**ADDENDUM NO. 2
LIFT STATION 15 VFD & POWER IMPROVEMENTS O.F 1817.1
GREAT FALLS, MT**

KLJ PROJECT # 2304-01761

Project: Lift Station 15 VFD's and Power Improvements – O.F. 1817.1

SHEET
E2R

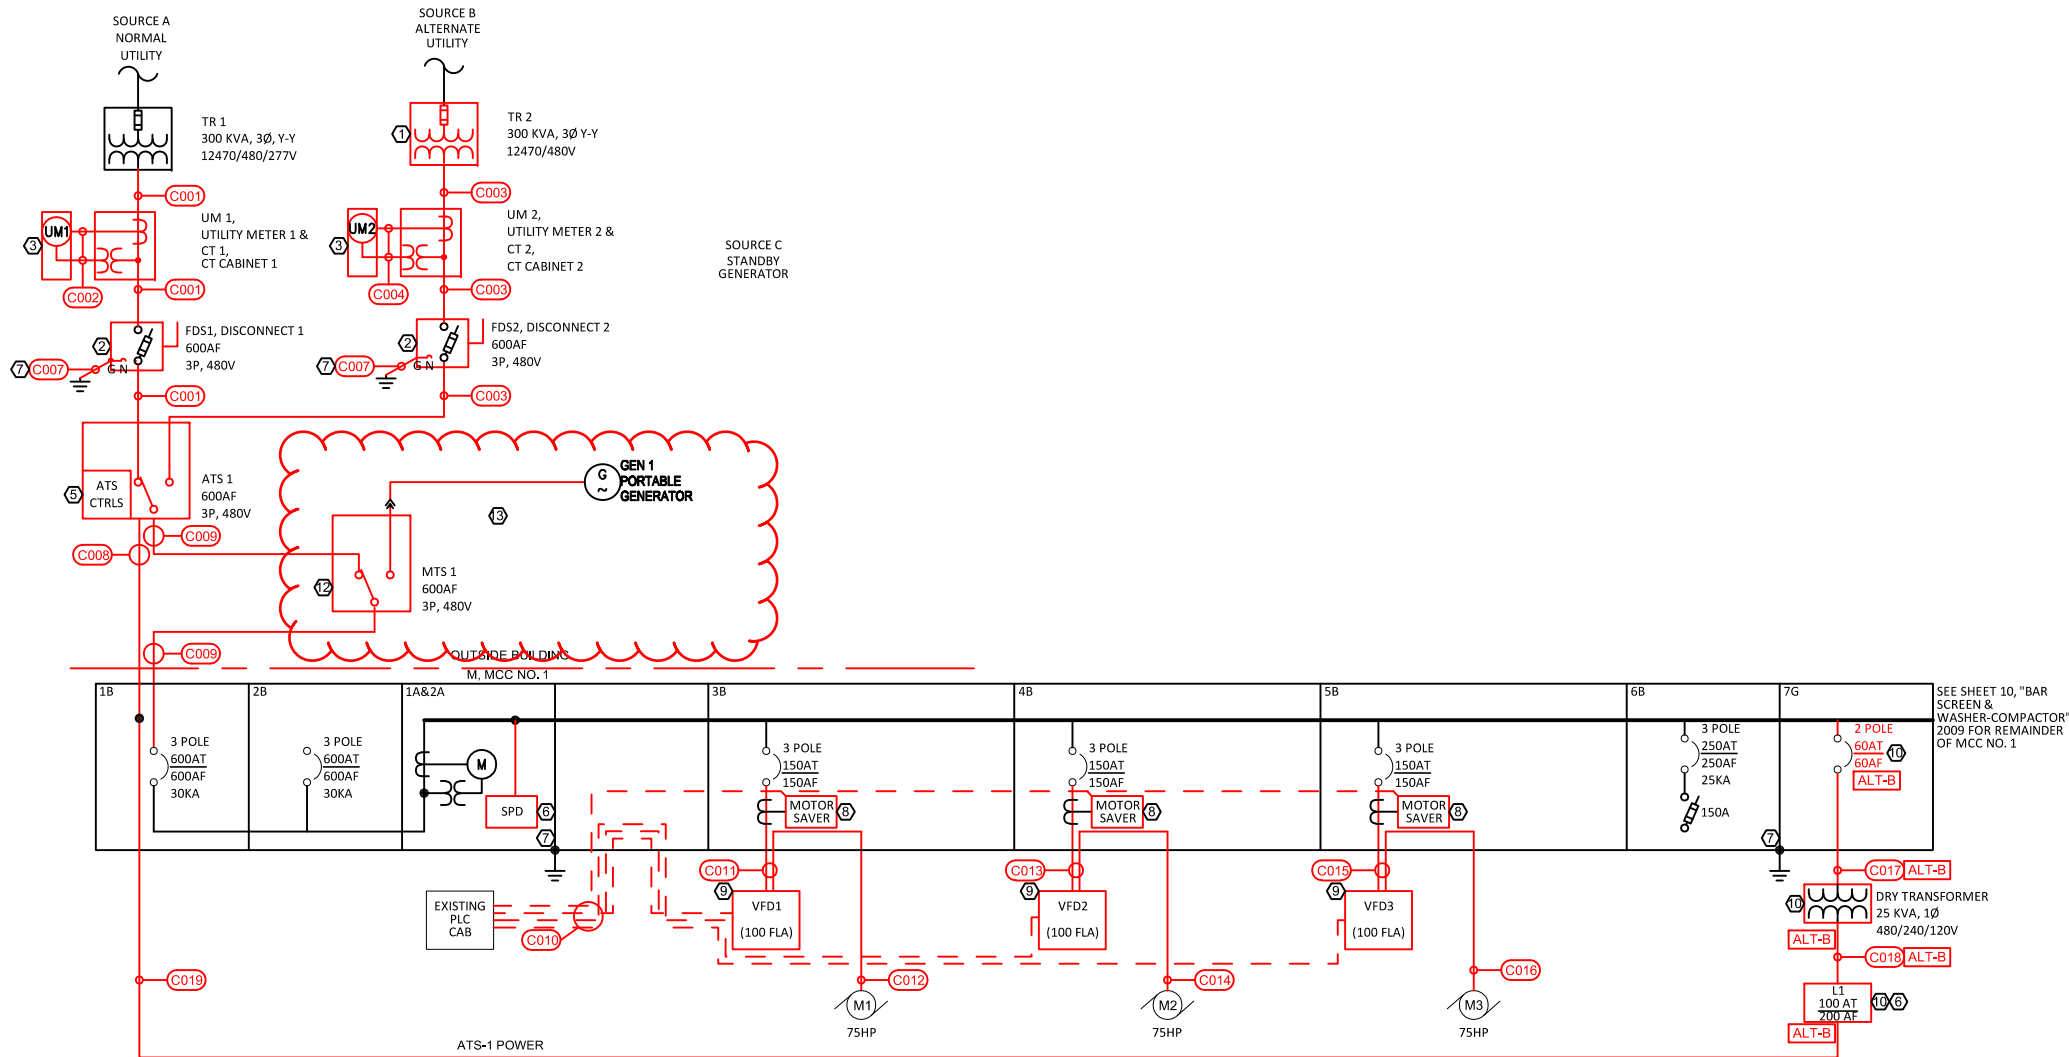
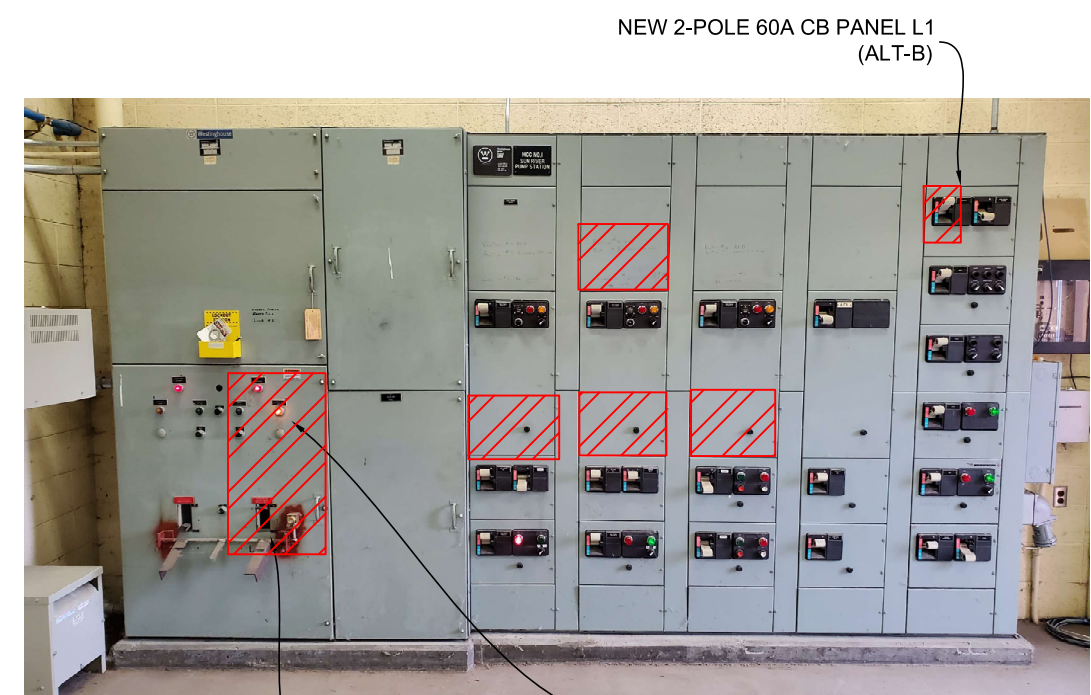
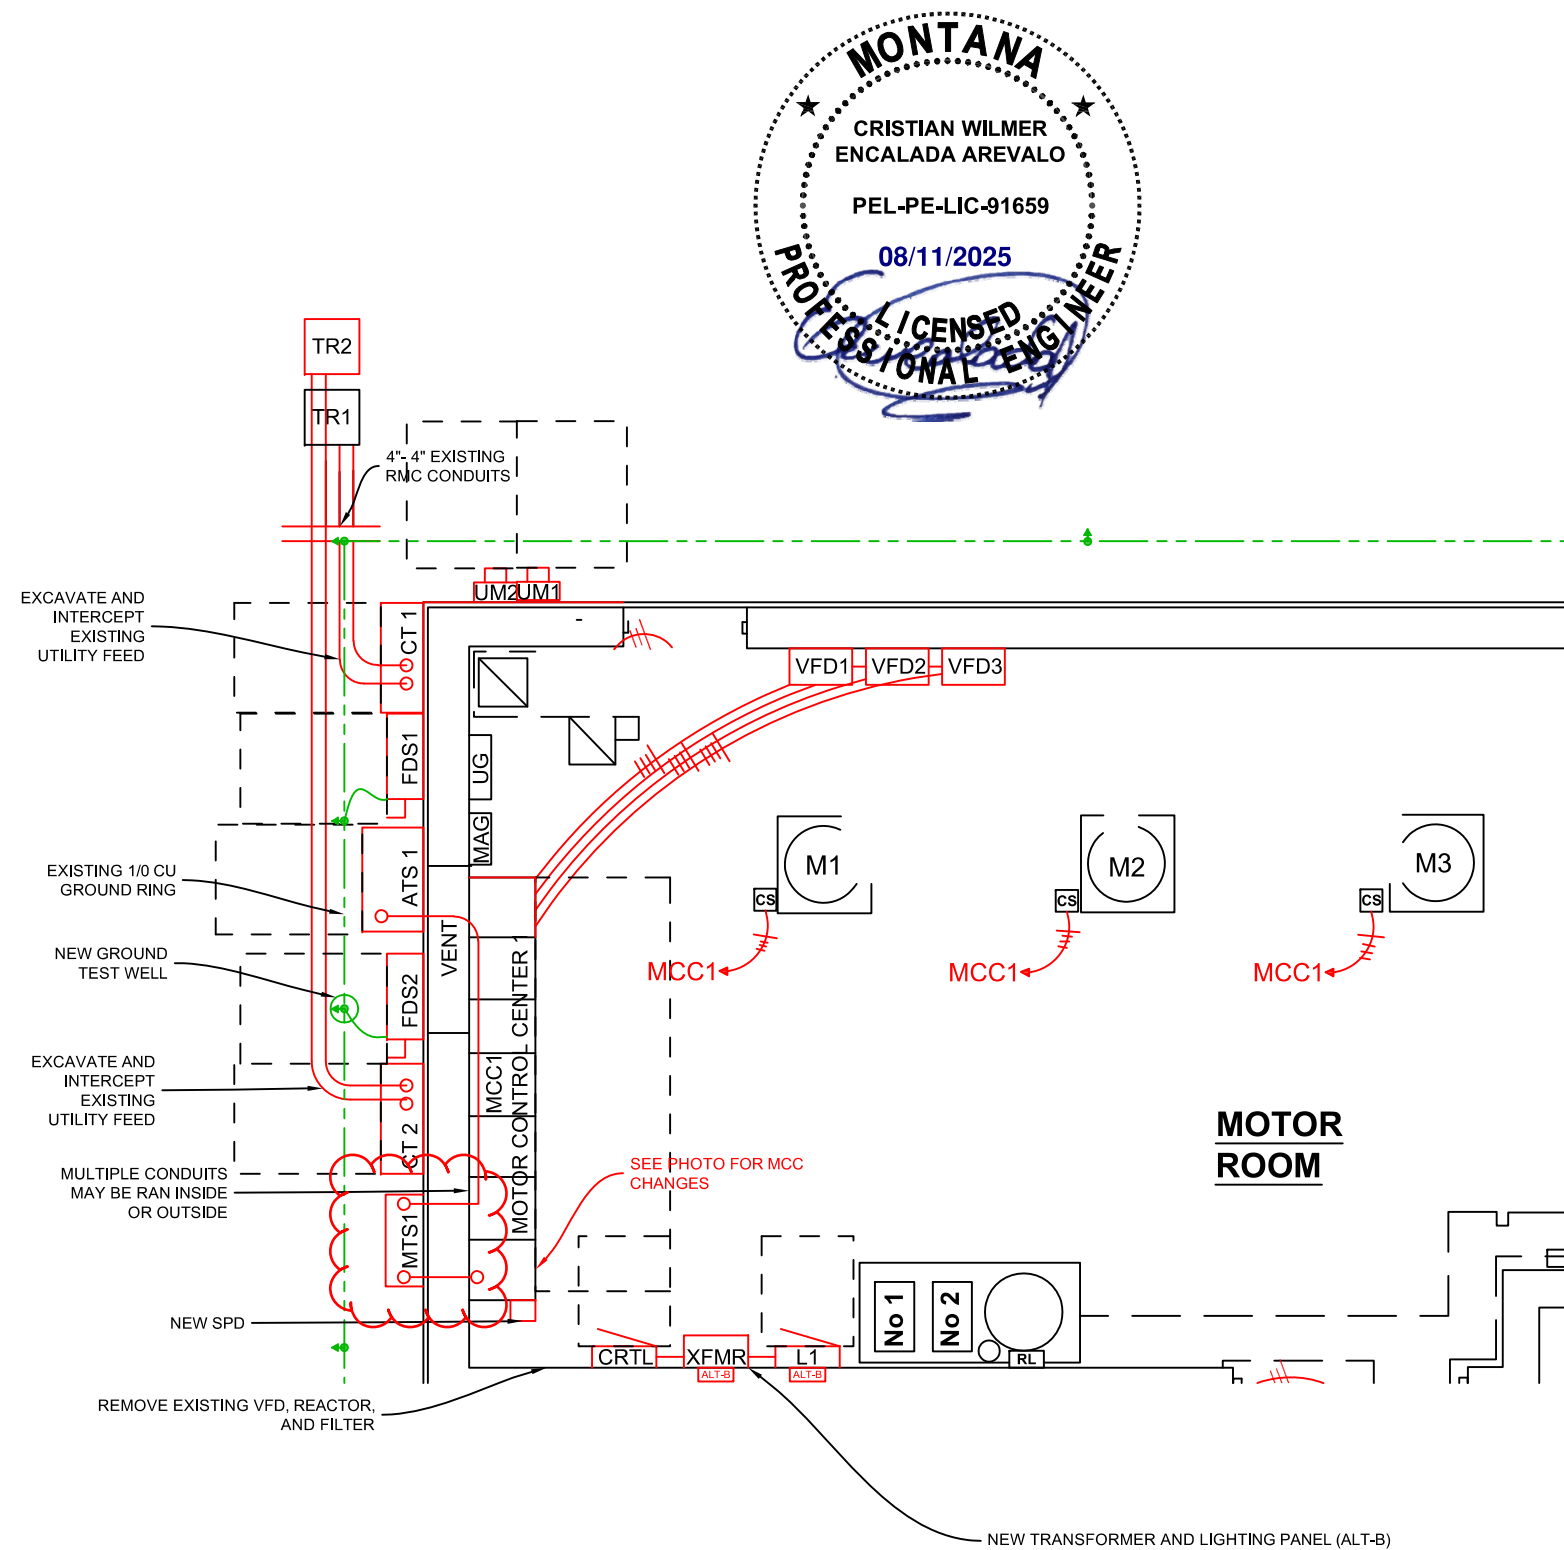
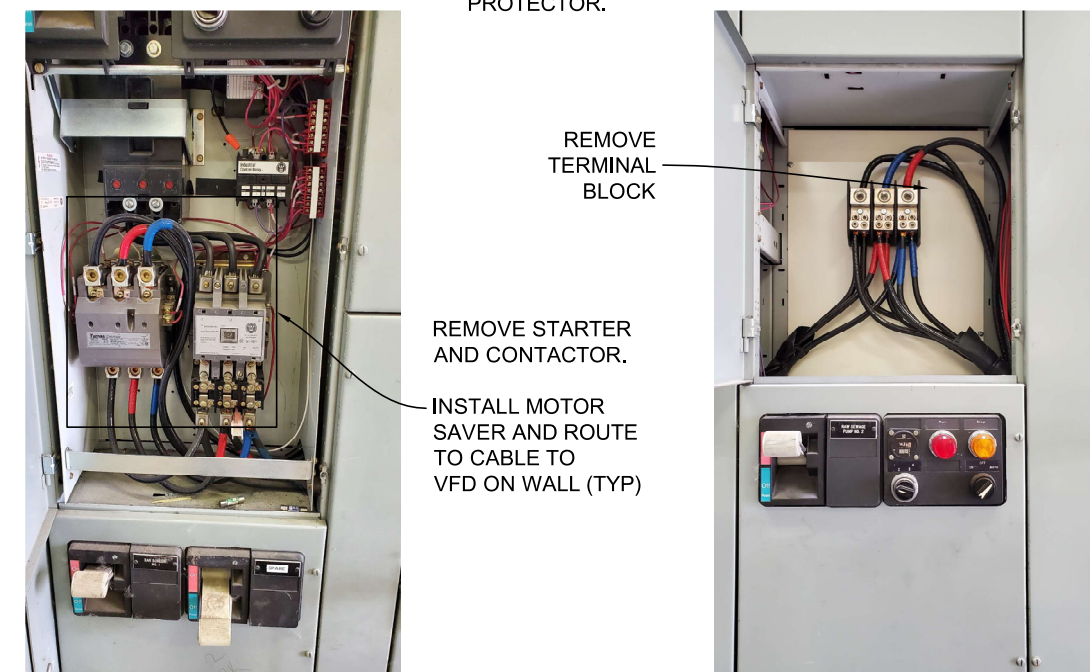
- UTILITY TO REMOVE EXISTING DELTA SECONDARY TRANSFORMER AND INSTALL WYE/WYE CONNECTED TRANSFORMER.
- INSTALL FUSED DISCONNECT SWITCH AND CONDUIT.
- INSTALL 3Ø INSTRUMENT RATED UTILITY METER SOCKET, CONDUIT, AND 36 INCH CT CABINET. UTILITY TO PROVIDE METER, CURRENT TRANSFORMERS, AND SECONDARY CABLES TO ATS1.

- REMOVE EXISTING CONTACTOR AND OVERLOAD AND INSTALL LITTLEFUSE MOTOR AND PUMP PROTECTION RELAY 777-ACCUPOWER WITH 100:5 CURRENT TRANSFORMERS.
- INSTALL VARIABLE FREQUENCY DRIVES PER SPECIFICATION 26 2923 INCLUDING PROGRAMMING AND MANUAL.

- FOR ALTERNATE BID B, REPLACE EXISTING LIGHTING PANEL SERVICE WITH 2-POLE 60A, 20KA CIRCUIT BREAKER, NEW CABLE, CONDUIT AS REQUIRED, 25KVA TRANSFORMER, AND NEW PANEL.

- INSTALL LOCKS ON ELECTRICAL BOXES, SMOOTH ANY SHARP EDGES ON SURFACES.
- INSTALL 600A MANUAL TRANSFER SWITCH. (POWER ASSEMBLIES PWA-MTS-06XE-5 OR EQUAL.)

- GENERATOR RECEPTACLE SHALL BE OUTDOOR RATED (NEMA 3R) AS MANUFACTURED BY APPLINGTON OR APPROVED EQUAL.

COVER EMERGENCY SOURCE CIRCUIT BREAKER. INSTALL SURGE PROTECTOR.
